### **Method of measuring the electric energy consumption and the pure electric range of vehicles powered by an electric power train only**

**Figure x**  
**Shortened NEDC test sequence**

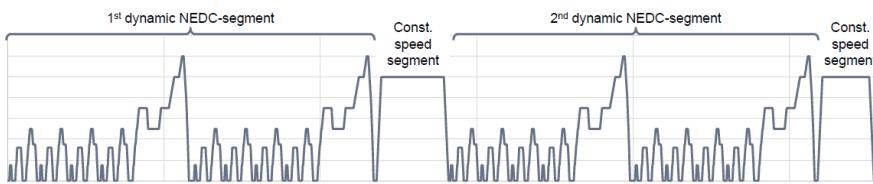
The shortened NEDC test sequence consists of two dynamic NEDC-segments ( $DS_1$  and  $DS_2$ ) combined with two constant speed segments ( $CSS_M$  and  $CSS_E$ ) as shown in the following figure.

The dynamic NEDC segments  $DS_1$  and  $DS_2$  are used to calculate the electric energy consumption. The constant speed segments  $CSS_M$  and  $CSS_E$  are intended to reduce test duration by depleting the REESS more rapidly than driving consecutively NEDC-cycles.

Figure 4  
Speed tolerance

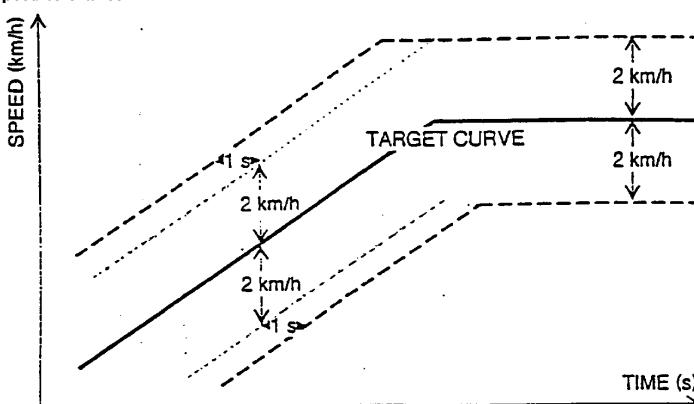
**Commented [OICA8]:** Are 50 km/h still reasonable? → to be discussed

**Commented [OICA9]:** Are 50 km/h still reasonable? → to be discussed
